Office Action Summary	Application No. 10/033,883	Applicant(s) YAO ET AL.	
	Examiner Roy M. Punnoose	Art Unit 2877

DETAILED ACTION

Figure 9 of the Klein Patent (US_4,554,460) is shown above.

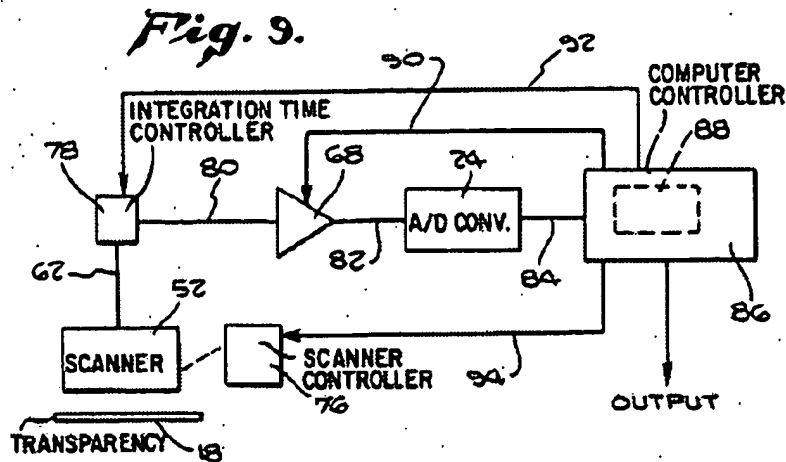
Klein discloses a scanning analyzer unit comprising:

A). A scanning processor unit 52 that scans the testing support 18, wherein the scanning processor unit 52 outputs a test signal 62 resulting from the scan of the testing support 18 (see Figure 9);

a signal amplifier 68 that is coupled with the scanning processor unit 52 to amplify the test signal 62, 80;

an analog/digital converter 24 that is coupled with the signal amplifier 68 and the computing unit 86, wherein the analog/digital converter 24 converts the amplified test signal 82 into a digital signal 84 that is transferred to the computing unit 86;

a computing unit 86 (see col.5, line 21) that is coupled with the scanning processor unit 52, wherein the computing unit 86 receives and analyzes the test signal 62;

a controller device 86 that is coupled with the scanning processor unit 52, wherein the controller device 86 outputs a driver signal 94; and,

a driver device 76 that is coupled with the controller device 86 and the scanning processor unit 52, wherein the driver device 76 receives the driver signal and accordingly drives the scanning processor unit 52 to accomplish the scan of the testing support 18 (see col. 5, lines 10-30), the scanning analyzer used for analyzing testing results that are obtained from a testing support for determining spectral quality of a sample under test (see col. 1, lines 6-31).

However, Klein does not teach of a scanning analyzer apparatus comprising separate computing unit and controller device for analyzing the test signal from the scanning processor unit and controlling a driver device based on the scanning processor unit output, the scanning analyzer apparatus used for analyzing testing results that are obtained from a testing support for determining spectral quality of a sample under test.

B). Klein teaches of a scanning analyzer apparatus comprising a combined computing unit and controller device 86 for analyzing the test signal from the scanning processor unit 52 and controlling a driver device 76 based on the scanning processor unit output 62 (see Figure 9; see col. 5, lines 10-30), the scanning analyzer apparatus used for analyzing testing results that are obtained from a testing support for determining spectral quality of a sample under test.

C). In view of Klein's teaching, it would have been obvious to one of ordinary skill in the art at the time the invention was made to modify Klein's apparatus by having a separate computing unit and a controller device due to the fact that such separate computing and controlling units would provide a modular system where each module can easily be replaced for repair and/or maintenance of the scanning analyzer apparatus, used for analyzing testing results that are
